The Energy from Waste (EfW) [SSD 6236] proposal by The Next Generation (NSW) Pty Ltd [TNG] has been on public exhibition.

- Letter from Office of Environment and Heritage (DOC 15/168903 SSD 6236) (21 July 2015)

Response to OEH - Biodiversity

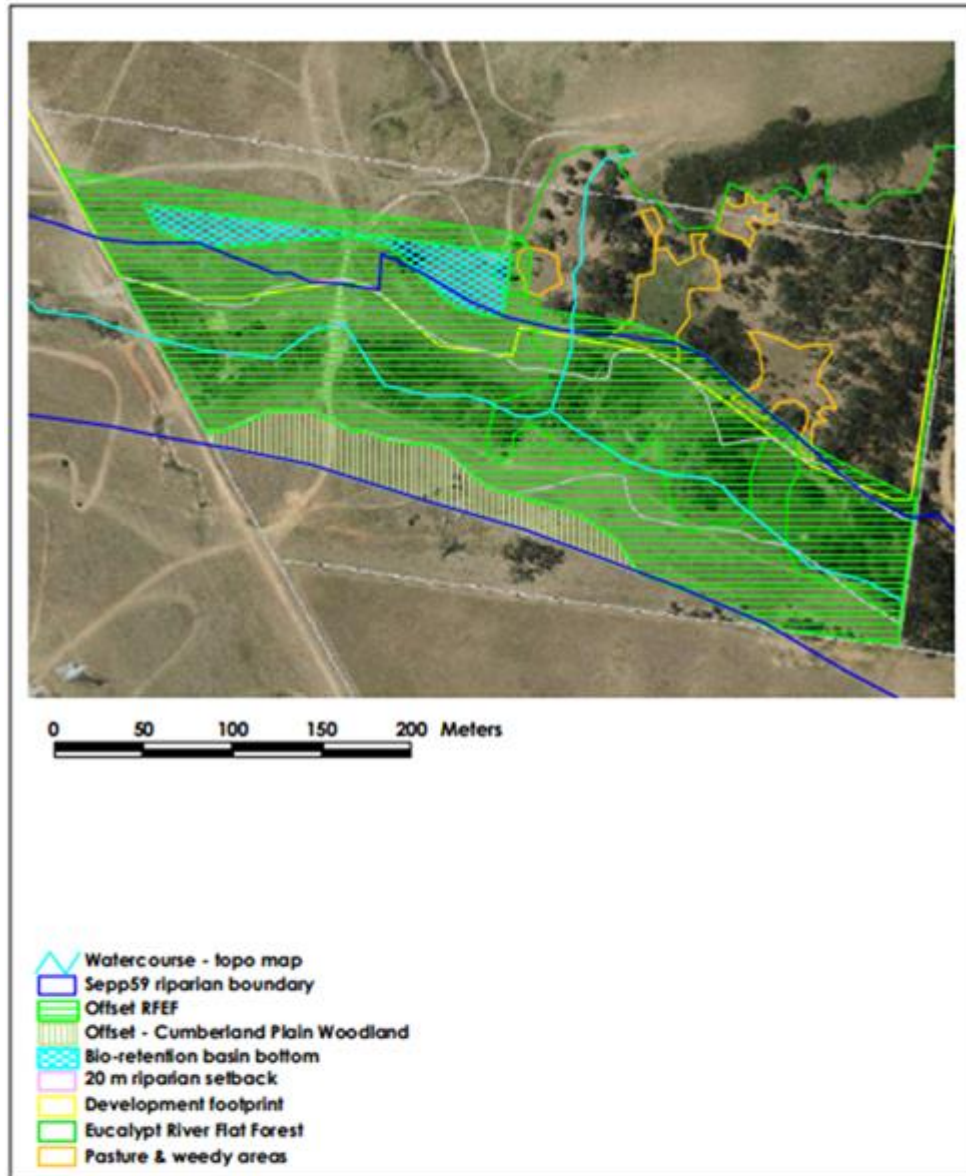
The area available for development is bounded in the south by a designated creek and riparian zone in which development is prohibited. This is shown on the following figures.

Figure 4: Existing vegetation and identified aboriginal site.

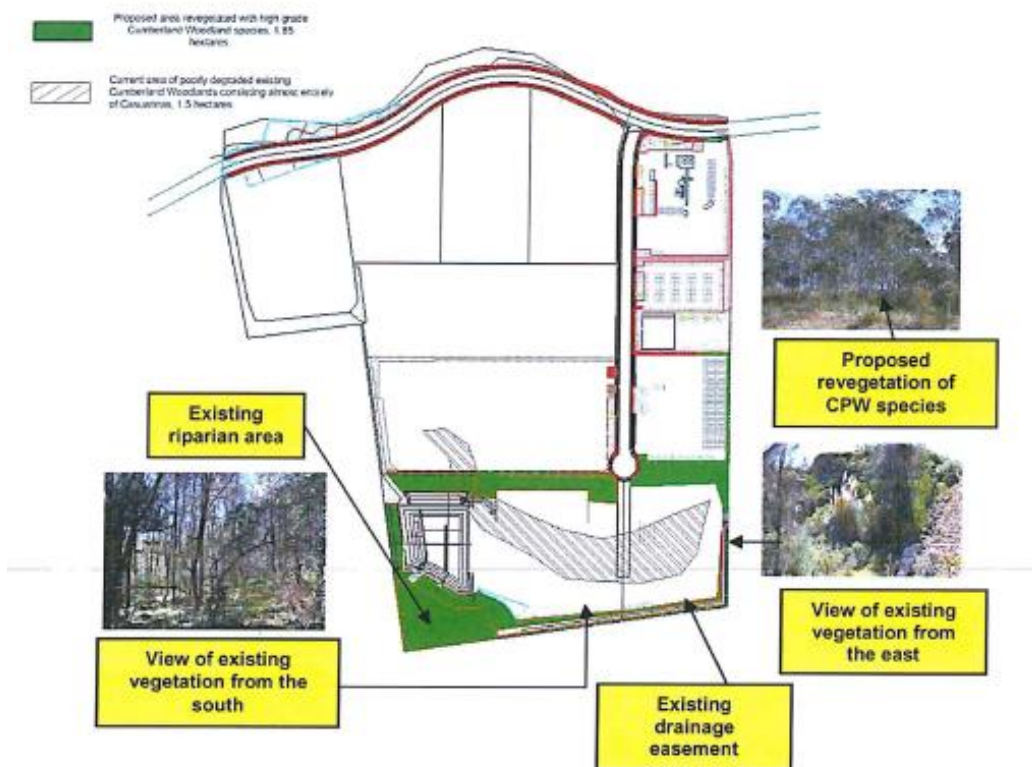
In its response to the Department in support of the modification Hanson proposed to Remove 1.5 Ha of trees and then

- Revegetate 1.85Ha of its site with Cumberland Plain Woodland (next figure)
- Develop a management strategy for the enhancement of riparian corridor vegetation in the south west corner.
- The riparian area to be fenced and segregated from the construction works, weeds removed and natural vegetation regenerated and maintained and
- To maintain the riparian area in perpetuity through a public positive covenant,

Figure 5: Existing vegetation and proposed revegetation are (in green).

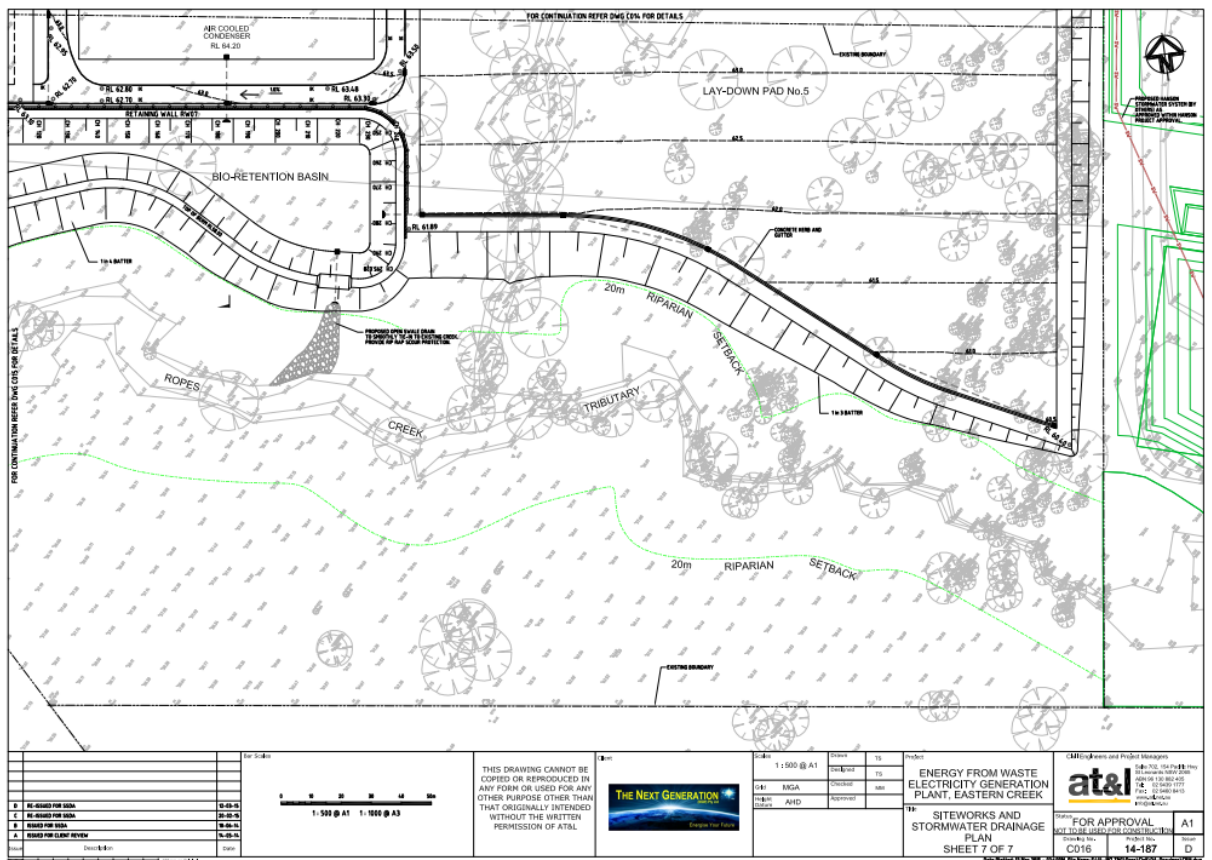
The Assessment Report concluded :.....the department has included these commitments as recommended conditions in the modified Project approval and considered that Hanson's proposed vegetation management strategies were appropriate for the vegetation to be retained on the site"¹⁷
